Narrabri Underground Mine Stage 3 Extension Project

Amendment Report

Figure 3

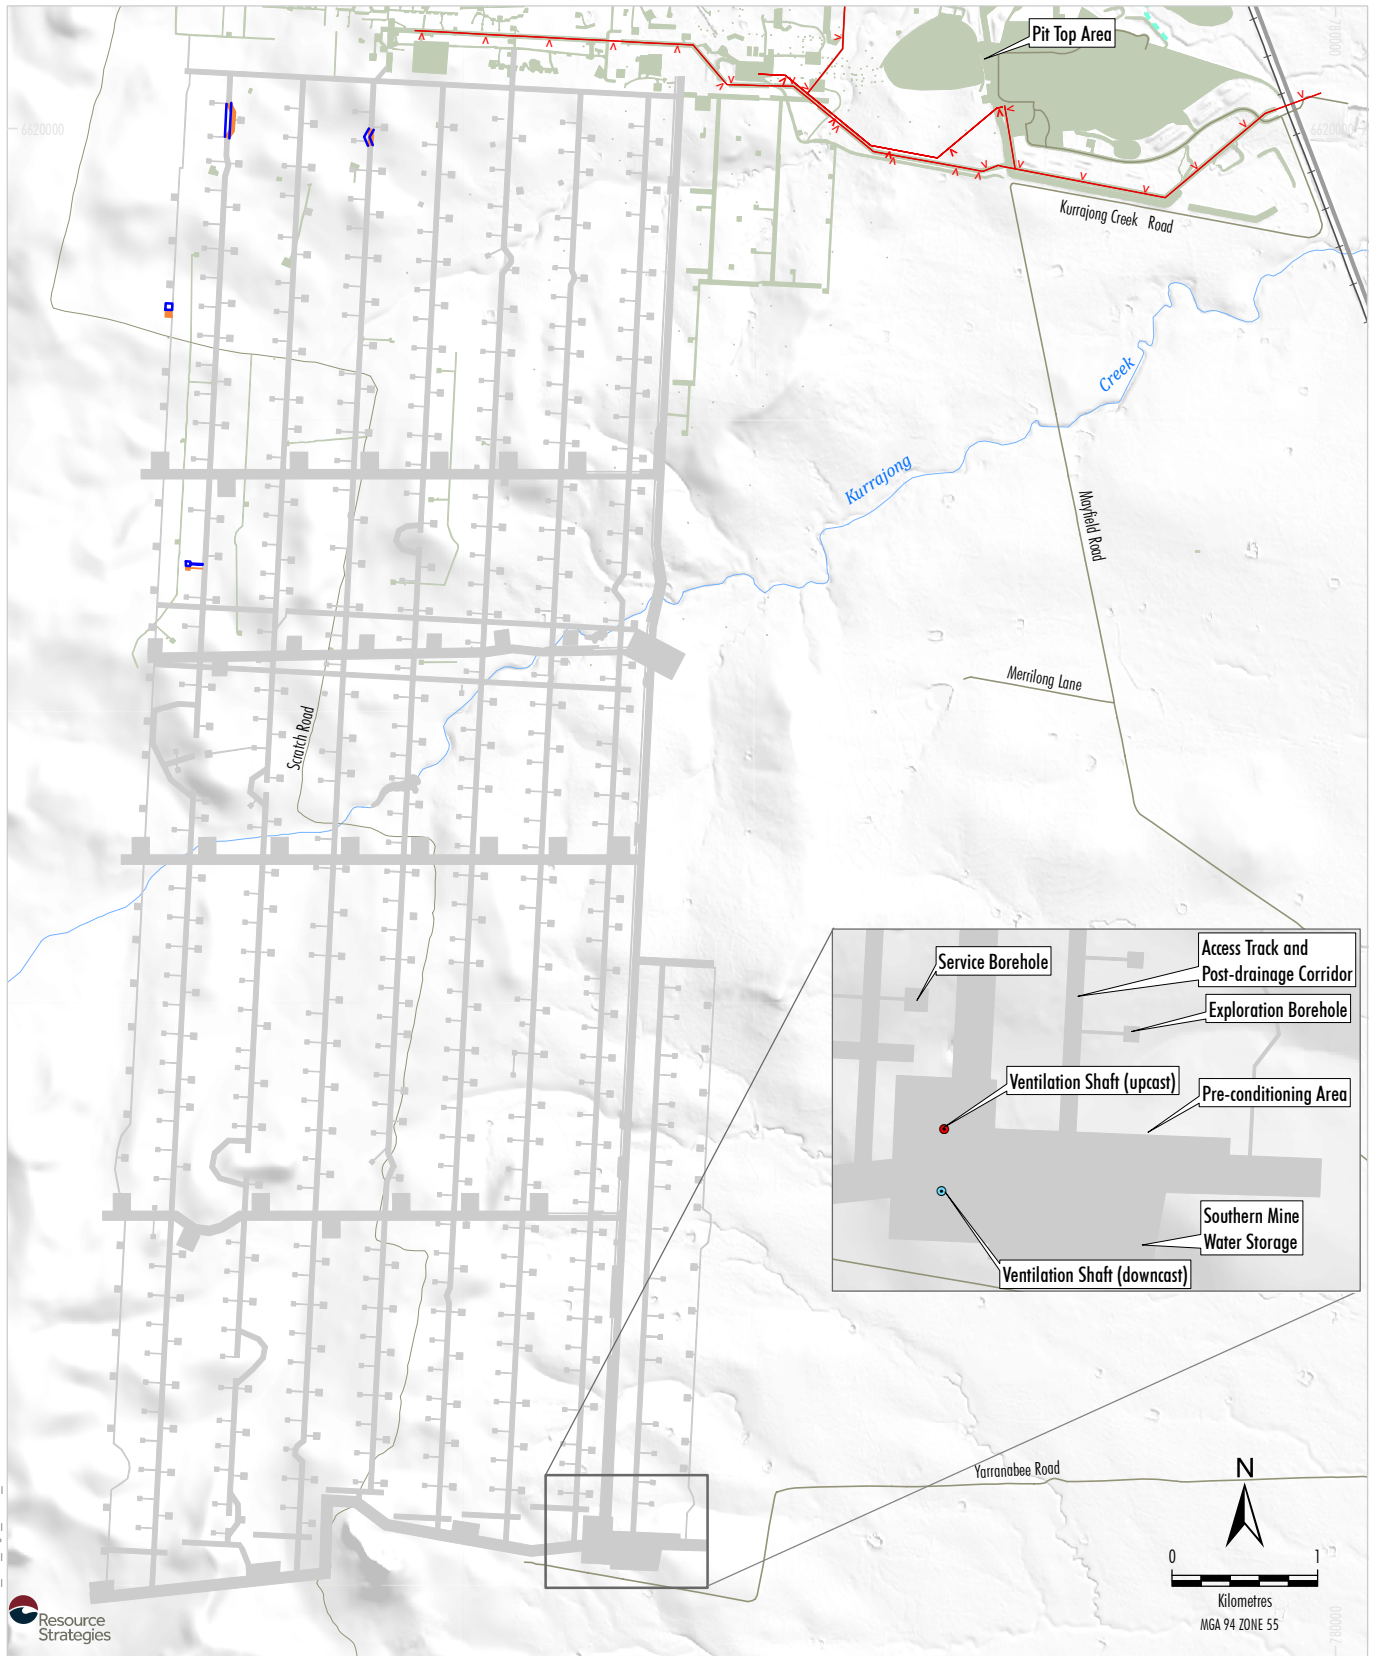
Additional gas management analysis undertaken by NCOPL has identified that in-seam gas volumes are expected to be lower in some areas compared with the estimates used for the Project design. NCOPL has confirmed that less pre-drainage underground in-seam drilling would be required to manage the gas volumes in some areas of the Narrabri Mine. The reduced pre-drainage drilling means that fewer service boreholes that connect the underground in-seam drilling to the surface are required. As a result, the number of service boreholes has been reduced substantially (i.e. by over 80 boreholes) (Figure 3) compared with the EIS.

Portions of the access track and post-drainage corridors have been narrowed from approximately 30 m to 10 m where goaf gas drainage is not required (Figure 3).

NCOPL has narrowed post-drainage corridors located outside of the longwall blocks from approximately 30 m to 10 m as goaf gas drilling is no longer required within those areas (Figure 3) (i.e. access is still required to be maintained in these areas however drilling is not required).

NARRABRI STAGE 3 PROJECT
Project General Arrangement -
Indicative Surface Development Footprint -
Amended Project Reductions to
Coolabah Bertya Impact
Figure 4

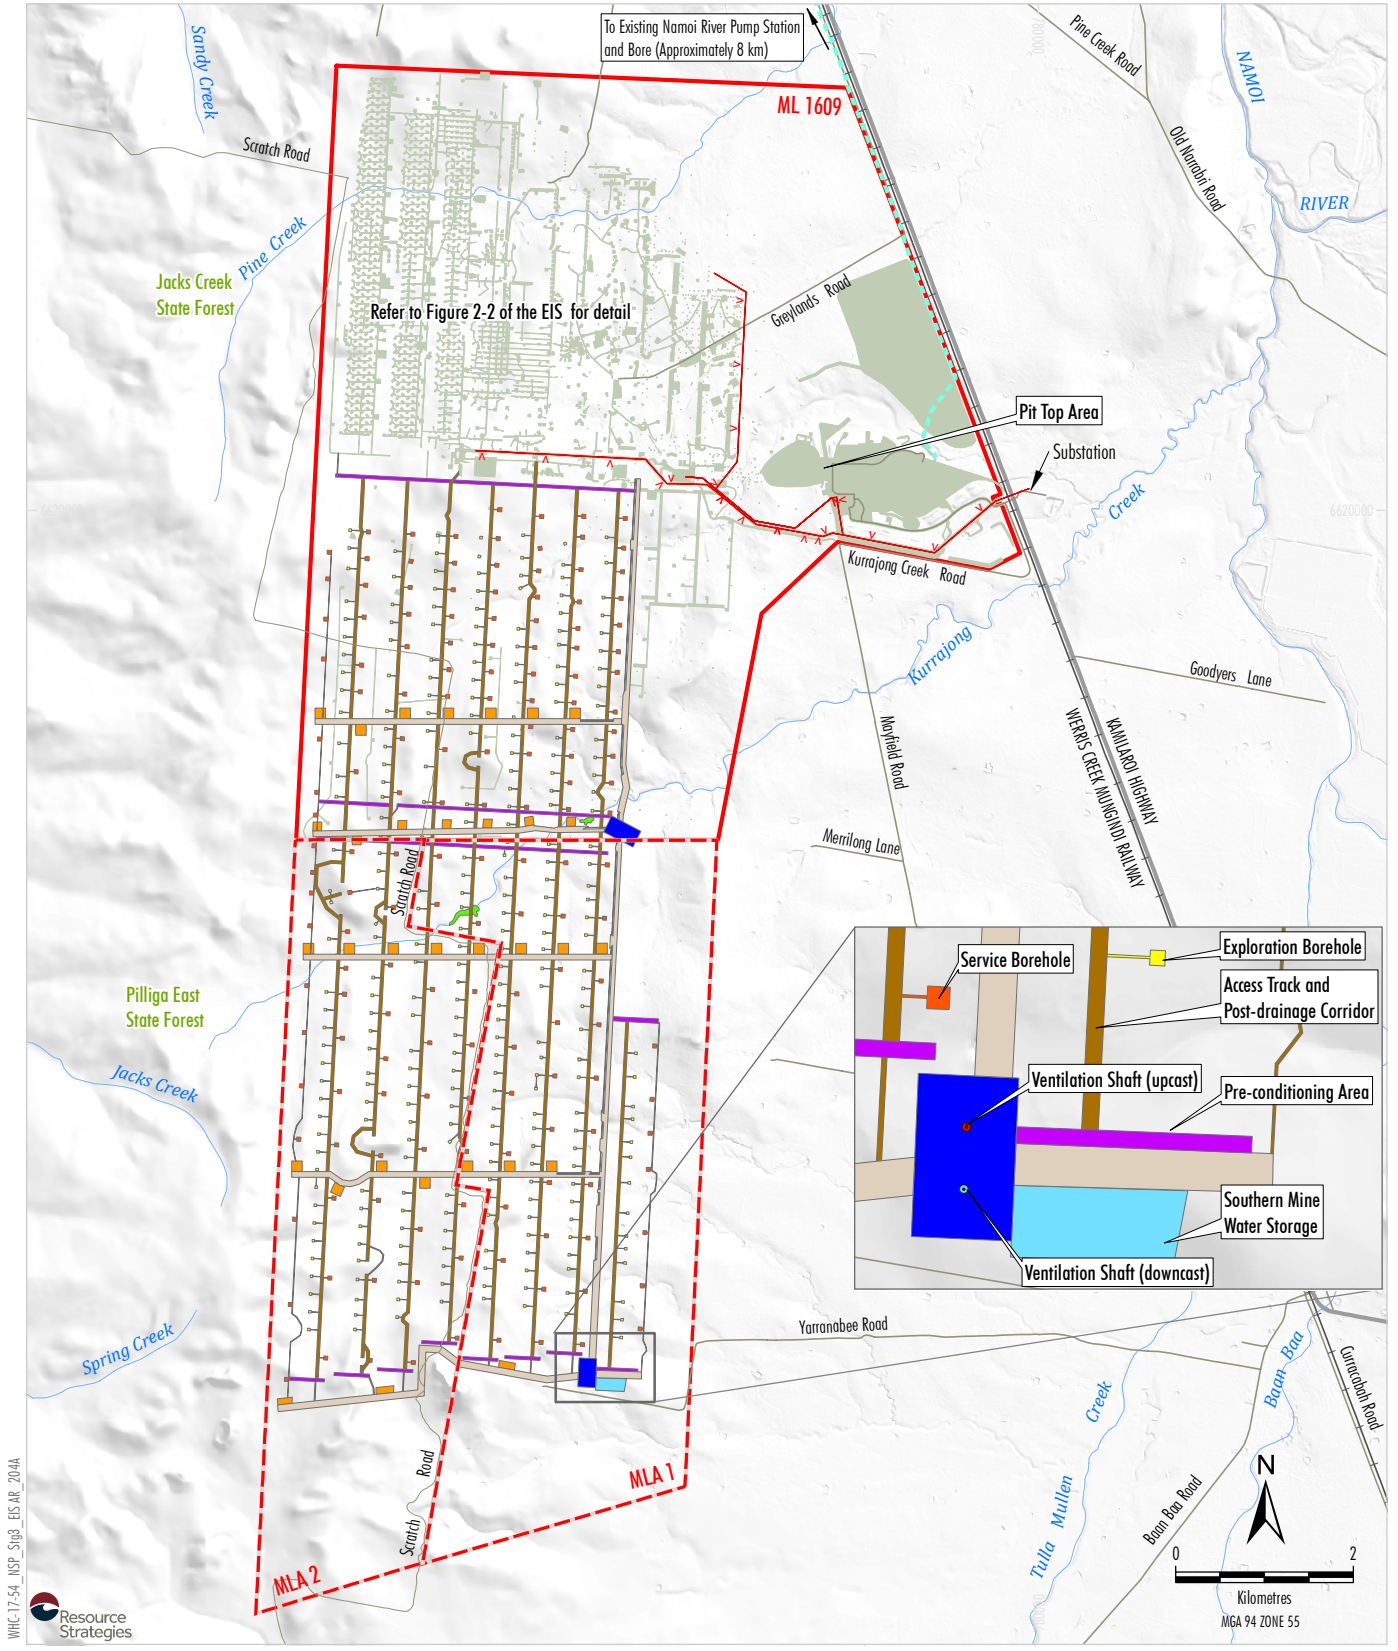
Since the lodgement of the Project EIS, NCOPL has continued to review the Project design and has identified opportunities to reduce the indicative Surface Development Footprint. The reductions include removal of exploration and service boreholes that are no longer required, narrowing of some access tracks and post-drainage corridors (Figure 3) and amendments to reduce the Project's impact on Coolabah Bertya (a threatened plant species) (Figure 4).

Figure 6
Pre-drainage Gas Zones (Source: Palaris [2021a])

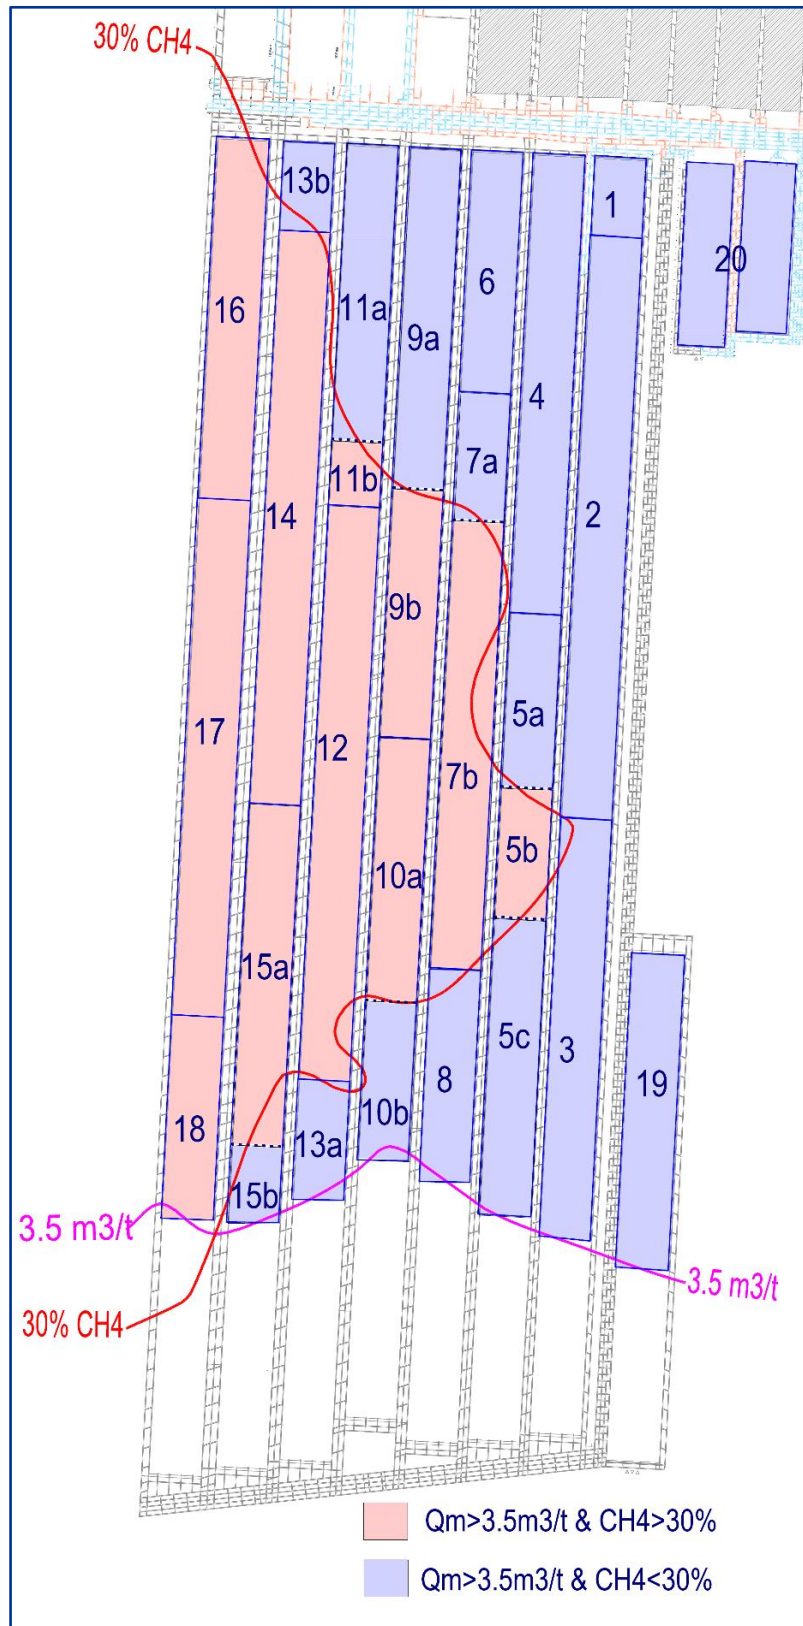
As part of ongoing Project design studies, Palaris has conducted a further review of the feasibility of flaring pre-drainage and post-drainage gas. As a result of the ongoing review of gas volumes and composition, Palaris (2021a) concluded that some areas of the underground mining area have methane content and gas composition levels which are suitable for flaring of the pre-drainage gas (Appendix B). Post-drainage gas was reviewed and it was identified that flaring of post-drainage was not possible due to the amount of oxygen within the gas stream being too high to safely flare (Palaris, 2021a). Accordingly, as part of the amended Project, NCOPL commits to flaring pre-drainage gas when the gas stream from the pre-drainage has a methane content of greater than 30%, and an oxygen content of less than 6%. Pre-drainage would only generally take place when the *in-situ* gas content of the Hoskissons Coal Seam is greater than 3.5 cubic metres per tonne of coal (m³/t of coal) (Palaris, 2021a). The approximate areas within the underground mine where these gas conditions are expected to occur are shown on Figure 6.
